Land Development and Transportation Committee

Staff Report

Case No:	19SUBDIV1004
Project Name:	Washington Green Section 2
Location:	6307 and 6503 Mt. Washington Rd
Owner(s):	JSWG LLC.
Applicant:	JSWG LLC.
Jurisdiction:	Louisville Metro
Council District:	23 – James Peden
Case Manager:	Jay Lockett, AICP, Planner I

- **Revised Major Preliminary Subdivision (Conservation)** with review of land disturbing activity on slopes greater than 20%.

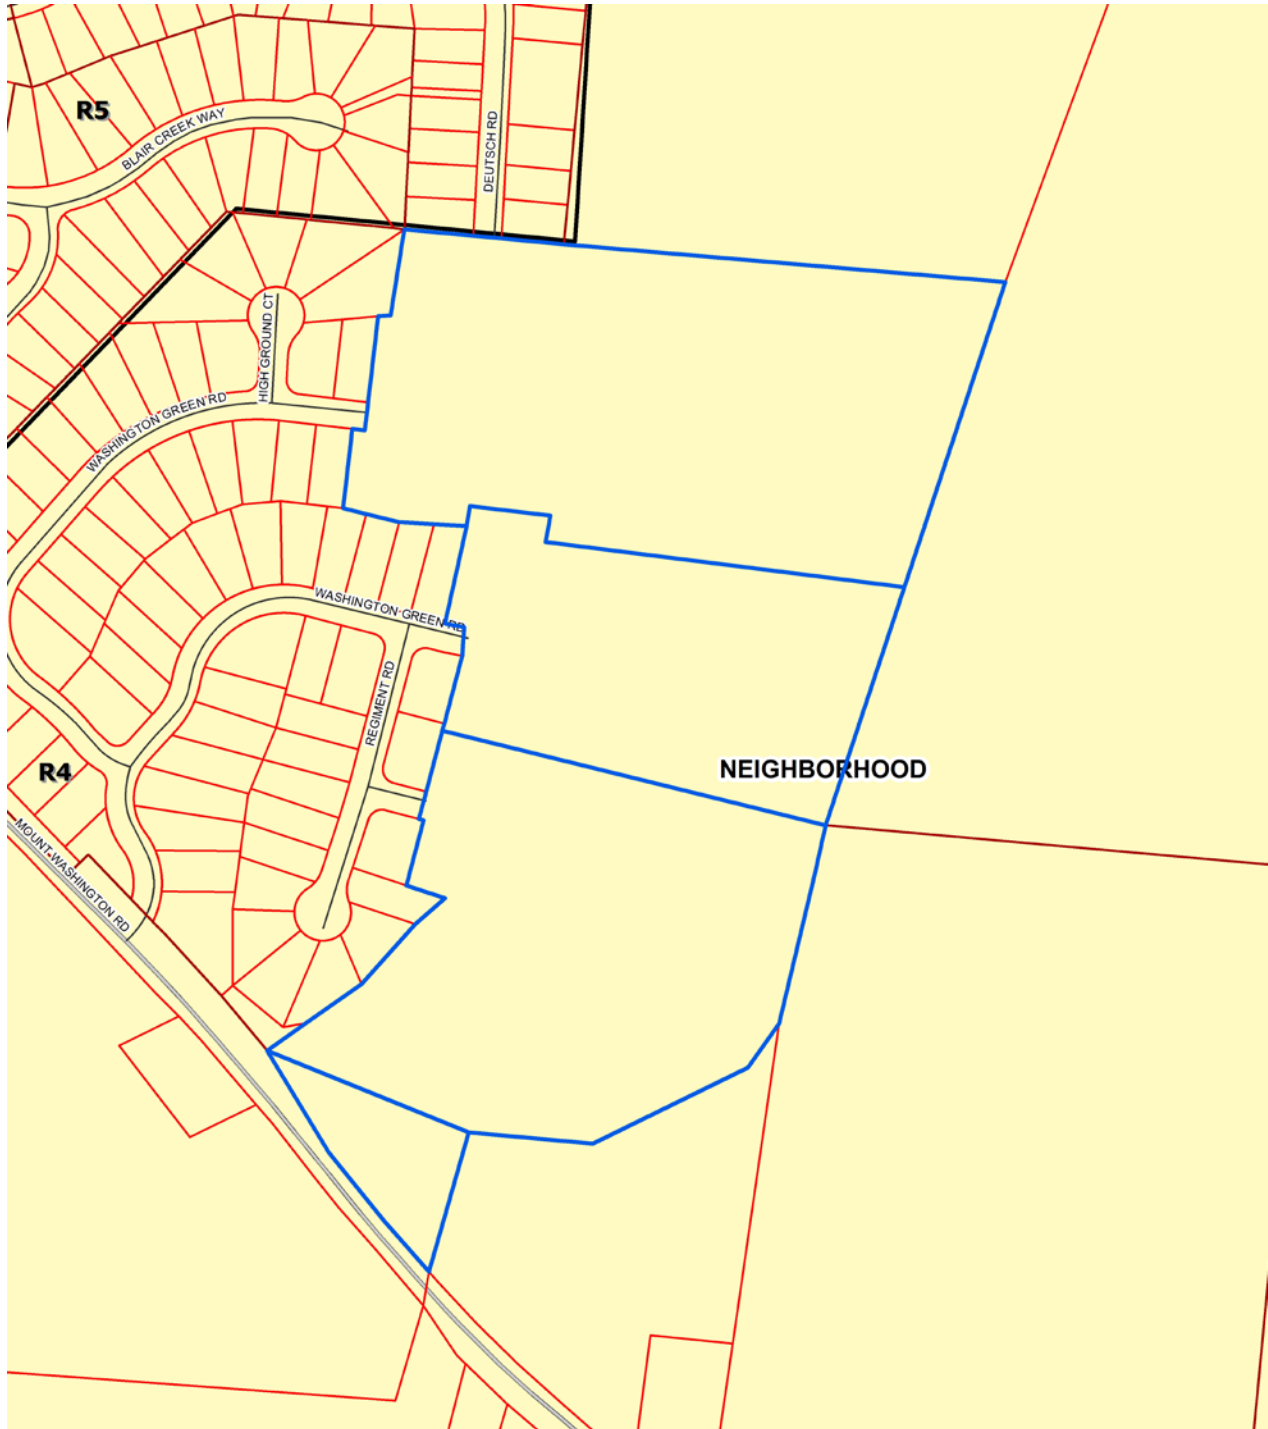
Metrosafe requests that the applicant rename the existing stub of Campfire Ct to match the proposed extension of Washington Green Rd.

STAFF: A professional geotechnical evaluation was performed and no significant concerns with respect to slope instability or substantial erosion were observed on these scattered lots. Lots 29 and 56 show some areas of slopes greater than 30% that were evaluated in the geotechnical report. Overall, the design and layout appears to be the minimum necessary accommodate the proposed use of the site.

STAFF: In general, the provided geotechnical report opines that the on-site slopes in the observed areas were stable at the time of observation. It provides that disturbance of slopes should not exceed the limits of evaluation in the report. Construction measures to maintain stability have been provided and should be incorporated into the construction of all new homes and the life of those homes.

STAFF: In general, preliminary soil and slope evaluation demonstrates that the proposal is in conformance with the policies of the Comprehensive Plan as construction methods have been provided to minimize property damage and environmental degradation related to disturbance of steep slopes. While some buildable lots are being placed in areas of concern, the majority of home construction will occur outside the areas of steeper slopes.
